**SUBJECT:** FASTENER ADJUSTMENT FOR THROTTLE WIRE**VEHICLE(S) AFFECTED:** MY2023 CFMOTO Ibex 800 Motorcycles (850 Total Affected VINs)**ISSUED:** August 21, 2024

CFMOTO-USA is issuing **MANDATORY Safety Bulletin SAF-2024-03**, requiring dealers to adjust the problematic configuration of throttle wire fasteners on their sold and unsold inventory of all affected MY23 Ibex 800 motorcycles.

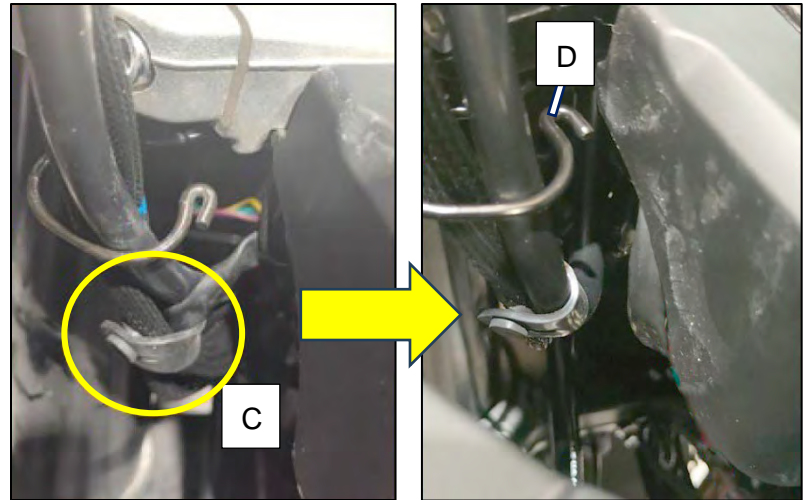
1. Locate the throttle wire and the 3 rubber clasps shown. Turn the handlebars to the left and right, and note for reference how the throttle wire bends with this configuration of clasps.
2. Remove and discard rubber clasp 'B'.

3. Undo rubber clasp 'C' and remove the throttle wire from it. Then redo the clasp.

**NOTE:** The throttle wire and other cables clasped together should remain within retaining bracket (D).

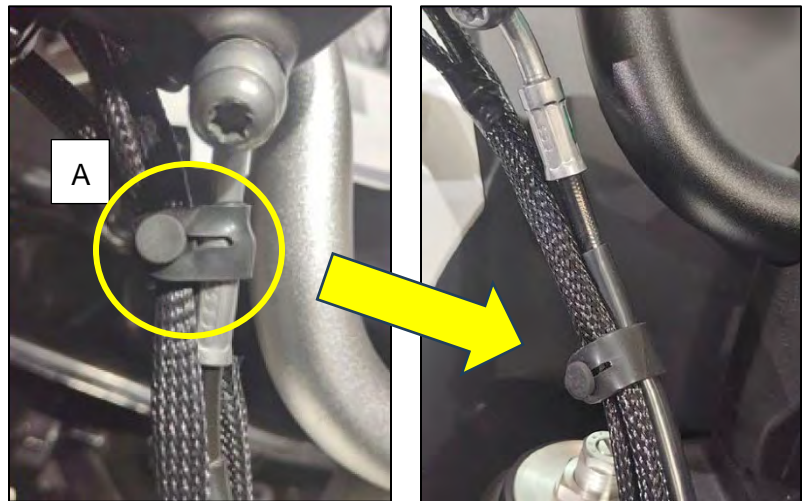
4. Move rubber clasp 'A' down approximately 1.5 to 2.5 inches to the position shown.

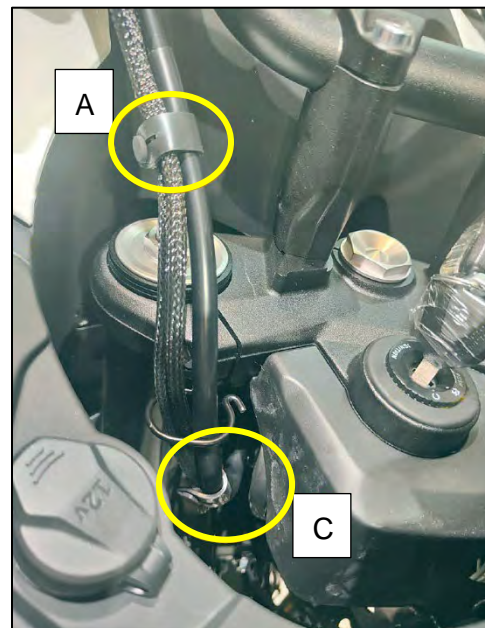
5. Turn the handlebars to the left and right, and check for excessive bending of the throttle wire. If necessary, adjust rubber clasp 'A' to lessen bending.
